Access Compliance Report

Public Rights-of-Way

(Curb Ramps)

Intersection ID: 3194	Main Street: HIGHCROFT_LN	Cross Street: OLD_BRIDGE_LN	Location: SE
ADA ID: 9E516E7228BF	Ramp Type: Perp	Initial Pass/Fail: Pass	Overall Compliance: No
		Severity Score: 0	
Codes/Mitigation Info/Possible Solution		Field Measurements/Component Compliance

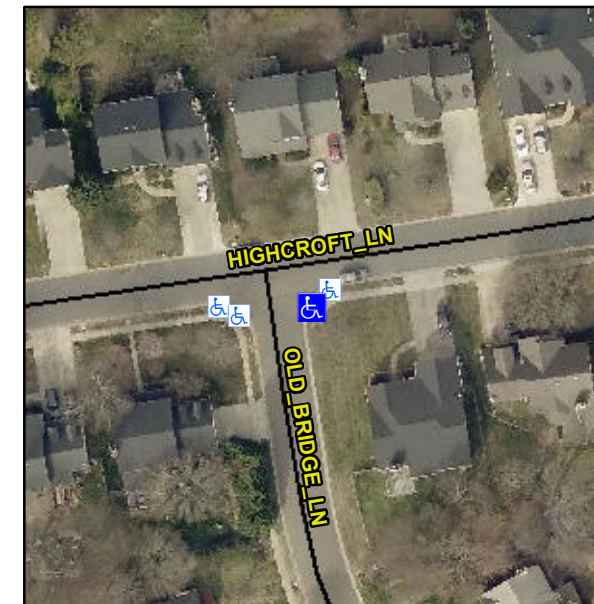
Not Found, R304.2.1, R304.2.2-Perp, R304.3.2-Para, R305.2

Compliance	Description	Data	Compliance	Description	Data
N/A	Ramp Length (in)	49.0	Yes	Ramp Slope (%)	7.3
Yes	Ramp Width (in)	48.0	Yes	Ramp XSlope (%)	1.3
N/A	Flare Type LT	Sloped	N/A	Flare Type RT	N/A
N/A	Flare Slope LT (%)	0.3	N/A	Flare Slope RT (%)	1.8
N/A	Flare Traversable LT?	No	N/A	Flare Traversable RT?	No
No	Landing Length (in)	47.0	Yes	DWS Provided?	Yes
Yes	Landing Width (in)	48.0	Yes	DWS Contrast?	Yes
No	Landing Slope (%)	3.0	Yes	DWS Length (in)	25.5
Yes	Landing X Slope (%)	0.3	Yes	DWS Full Width?	Yes
N/A	Landing Curb? (Y/N)	No	No	DWS Offset (in)	3.0
N/A	Shared Landing?	No			
Yes	Gutter Ponding?	No	Yes	Gutter Slope (%)	1.0
Yes	Gutter Lip Ht (in)	0.0	Yes	Gutter X Slope (%)	0.3
N/A	Painted X Walk1?	No	N/A	Painted X Walk2?	N/A
	X Walk 1 Direction	To W		X Walk 2 Direction	N/A
N/A	X Walk 1 Width (in)	N/A	N/A	X Walk 2 Width (in)	N/A
	X Walk 1 Slope (%)	3.4		X Walk 2 Slope (%)	N/A
	X Walk 1 X Slope (%)	2.3		X Walk 2 X Slope (%)	N/A

N/A	Ramp inside XWalk1?	N/A	N/A	Ramp inside XWalk2?	N/A
	Road Slope (%)	N/A	N/A	Clear Space?	Yes
	Road X Slope (%)	N/A	N/A	Clear Space to XWalk (in)	N/A
Yes	Any Obstructions?	No	Yes	Storm Grate/Utility Hazard?	No
	Obstruction Type			Storm Grate/Utility Type	
		N/A			N/A
			Yes	Surface Condition? (G/P)	Good

Remove & Replace Entire Ramp.
